Duke Power Company
A Duke Energy Company

McGuire Nuclear Station
MG01VP
12700 Hagers Ferry Rd.
Huntersville, NC 28078-9340

SUBJECT: Duke Energy Corporation (DEC) McGuire Nuclear Station
Units 1 and 2 Docket Nos. 50-369/50-370
Proposed Technical Specification (TS) Amendments TS
3.7.15 - Spent Fuel Assembly Storage, and TS 4.3 -
Fuel Storage

Attachment 1 provides marked up pages of the existing McGuire TSs showing the proposed changes. Attachment 2 contains the new McGuire TS pages. The Description of Proposed Changes and Technical Justification is provided in Attachment 3. Pursuant to 10CFR50.92, Attachment 4 documents the determination that this proposed amendment contains no significant hazards considerations. Pursuant to 10CFR51.22 (c)(9), Attachment 5 provides the basis for the categorical exclusion from performing an Environmental Assessment or Impact Statement. The McGuire Spent Fuel Pool Criticality Analysis, and the McGuire Boraflex Degradation Analysis used to support this LAR are shown in Attachments 6 and 7, respectively. Also, please refer to Attachment 7 of the referenced letter for the supporting McGuire Spent Fuel Pool Dilution Analysis Summary used to support this

Table 3.7.15-7 (page 1 of 1)
Minimum Qualifying Burnup Versus Initial Enrichment
for Unrestricted Region 2A Storage

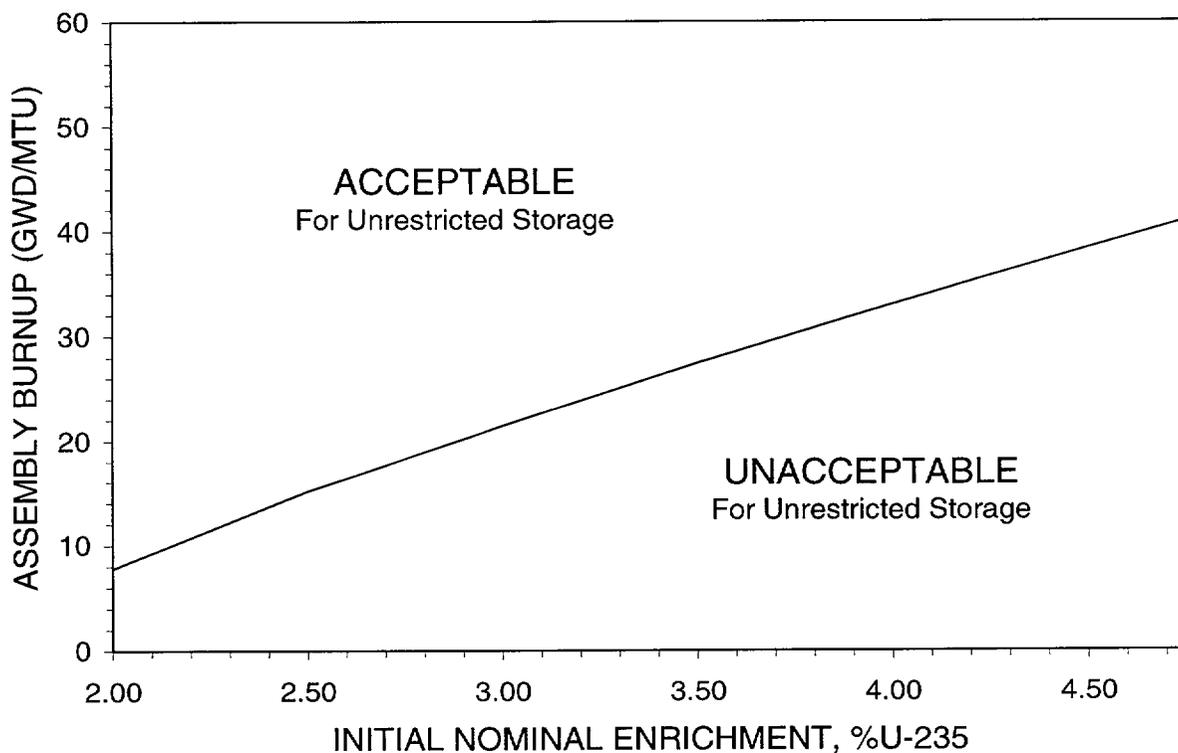
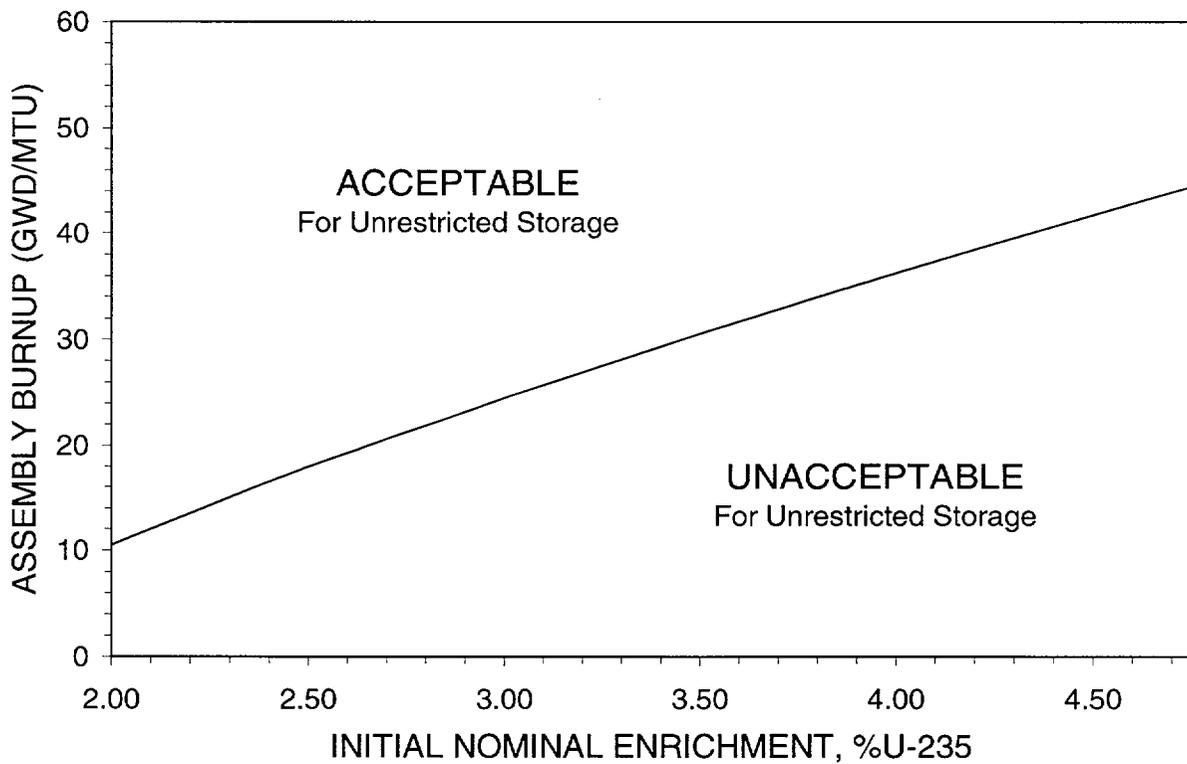
2. McGuire TS 3.7.15 will be revised to provide revised spent fuel pool storage criteria and revised fuel enrichment and burnup requirements for McGuire Region 2A. With the applicable minimum concentration of soluble boron present in the spent fuel storage pool and reduced credit for the degraded spent fuel rack Boraflex neutron absorber panels in Region 2A, these changes will ensure that the pool storage rack k_{eff} is ≤ 0.95 under non-accident conditions (including the unlikely occurrence of a worst-case spent fuel storage pool dilution event with thorough mixing) and accident conditions. The applicable minimum concentration of soluble boron is ensured by existing McGuire TS 3.7.14.

<u>Initial Nominal Enrichment</u> <u>(% U-235)</u>	<u>Assembly Burnup</u> <u>(GWD/MTU)</u>
1.50 (or less)	0.00
2.00	10.50
2.50	17.97
3.00	24.49
3.50	30.55
4.00	36.25
4.50	41.71
4.75	44.39

Figure 3.7.15-2 (page 1 of 1)
Required 2 out of 4 Loading Pattern for Restricted Region 1B Storage

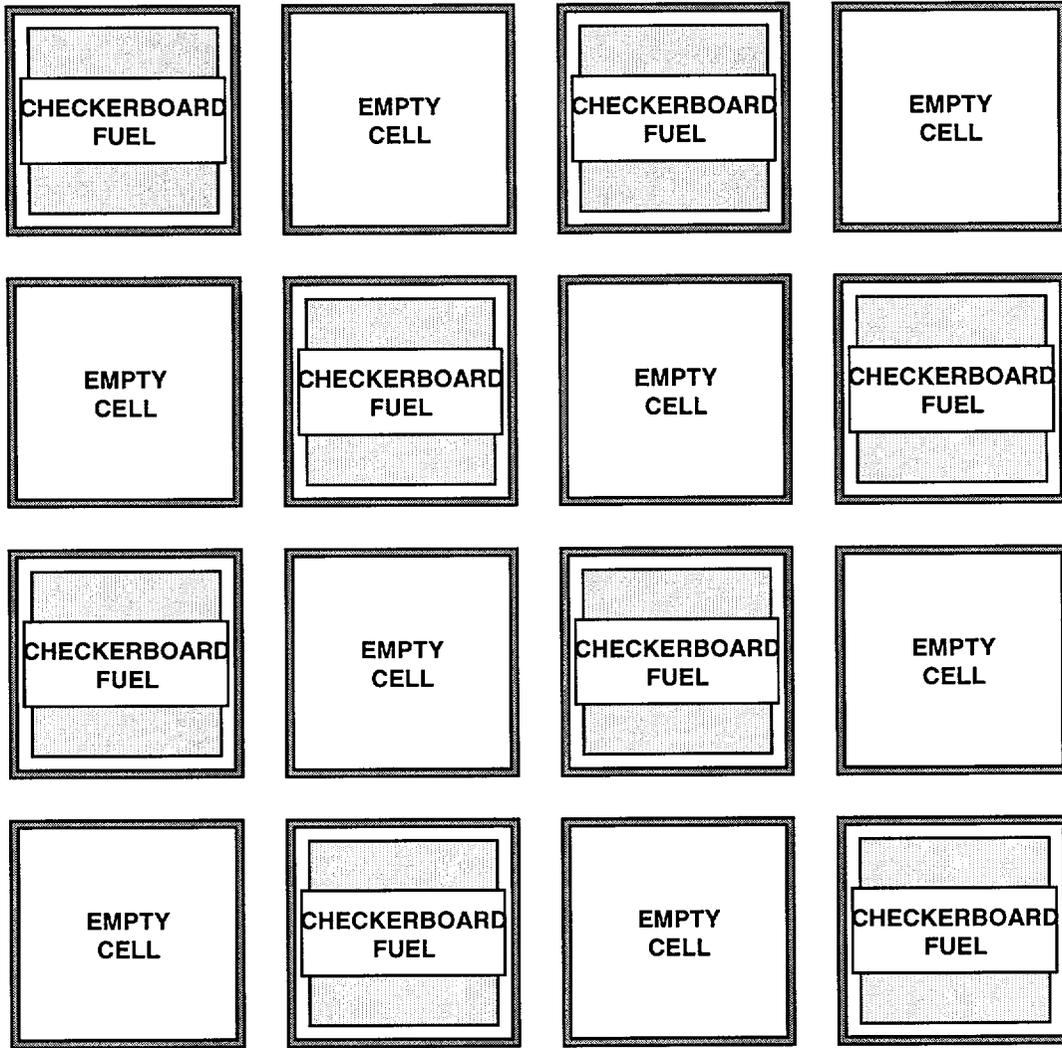
Boundary Condition: ~~No restrictions on boundary assemblies.~~ Any Restricted Region 1B Storage Area must be separated from any other storage area by at least one row of 1B Filler Locations or empty cells, at all boundaries between storage regions.

3. McGuire TS 3.7.15 will also be revised to require more restrictive boundary conditions between storage regions for McGuire Regions 1B and 2A. Boundary conditions for Region 1B are changing because of a change to the required shape of the storage configurations. Currently, Region 1B storage configurations must be rows extending from one side of the rack to the other side. The proposed more restrictive storage configurations will allow storage in rectangular arrays of any size. Boundary conditions for Region 2A are changing due to the change from 50% boraflex credit to 40% boraflex credit.

Figure 3.7.15-3 (page 1 of 1)
Required 2 out of 4 Loading Pattern for Checkerboard Region 1B Storage

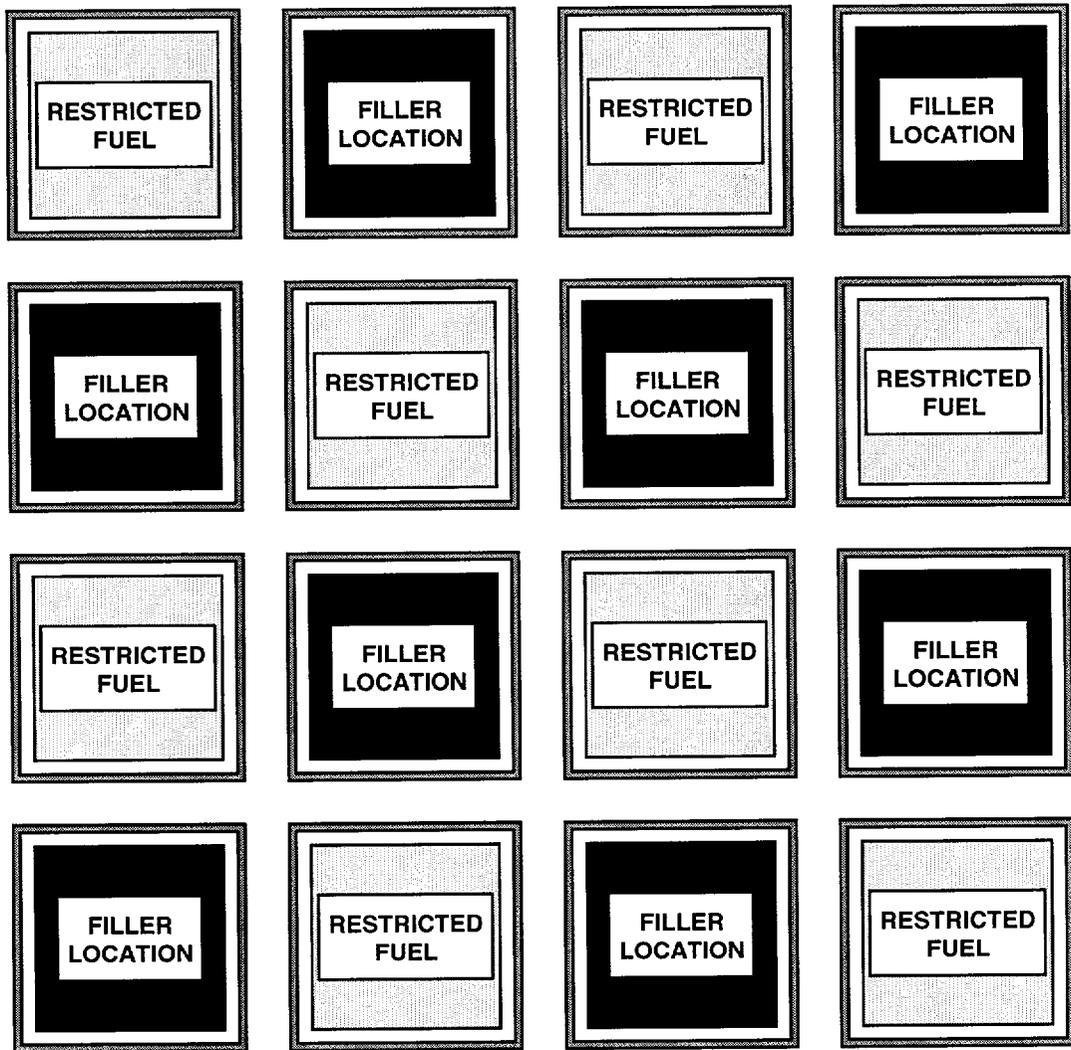
Boundary Condition: ~~No restrictions on boundary assemblies.~~ Any Checkerboard Region 1B Storage Area must be separated from any other storage area by at least one row of empty cells, at all boundaries between storage regions.

Figure 3.7.15-4 (page 1 of 1)
Required 2 out of 4 Loading Pattern for Restricted Region 2A Storage

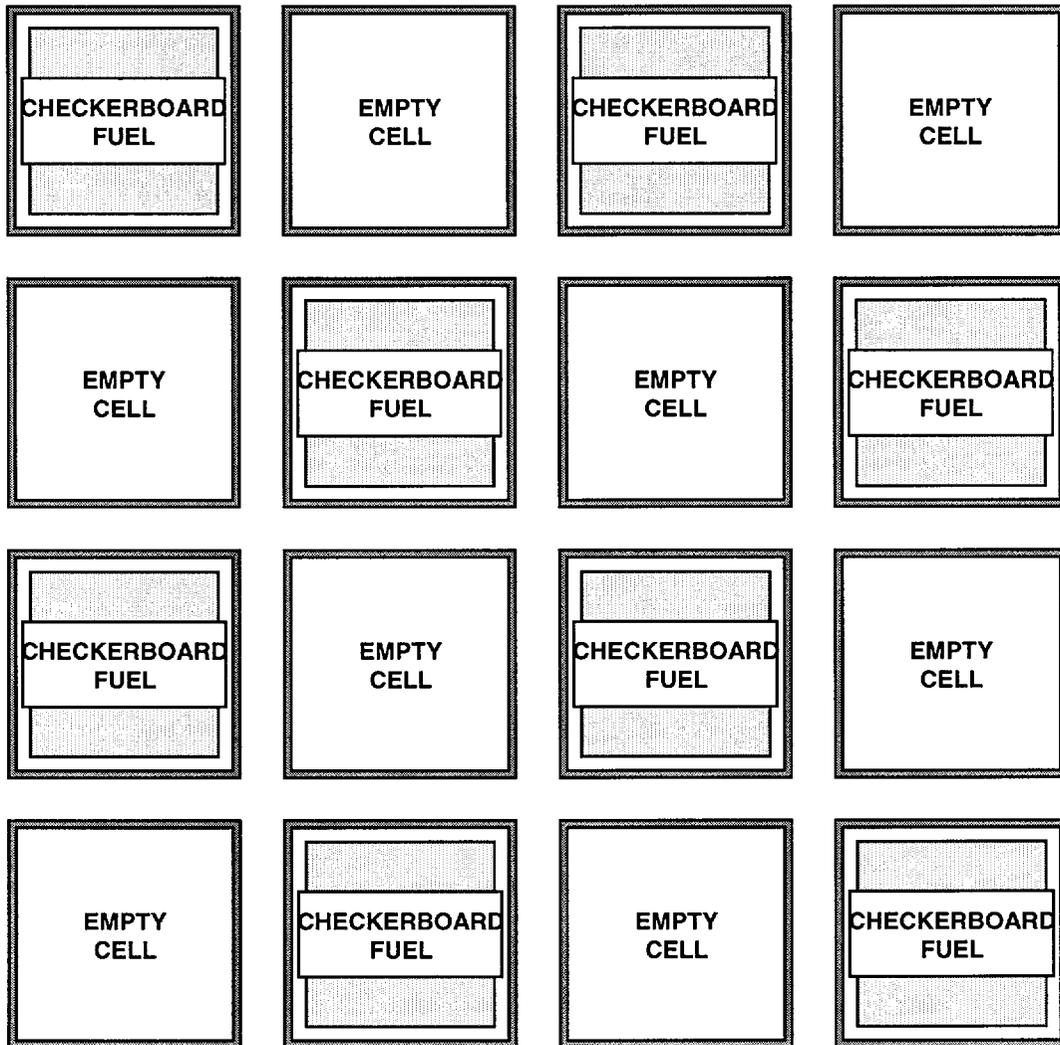
Boundary Condition: ~~No restrictions on boundary assemblies.~~ At least three of the four faces of each 2A Restricted Fuel assembly must be adjacent to a 2A Filler Location, an empty cell, or the pool wall, at all boundaries between storage regions.
